50-329/330 OM, OL
Midland Plant, Unit 1&2

Exhibits of John P. Matra, Jr. 5154]

Oral Deposition on 1/7/81

NUCLEAR POWER FACILITY NAME: MIDLAND PLANT
 STRUCTURAL DATA SHEET UNITS 1 AND 2

RG 1.59 B HAZARDOUS PROTECTION APPROACH

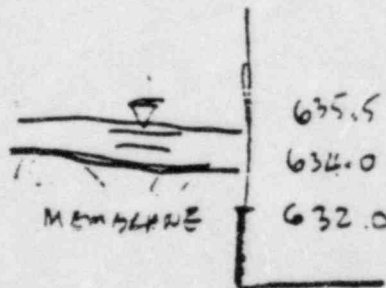
Q WHAT IS THIS HAZARDOUS APPROACH
HOW THE USE OF TWO CRITERIA EFFECTS
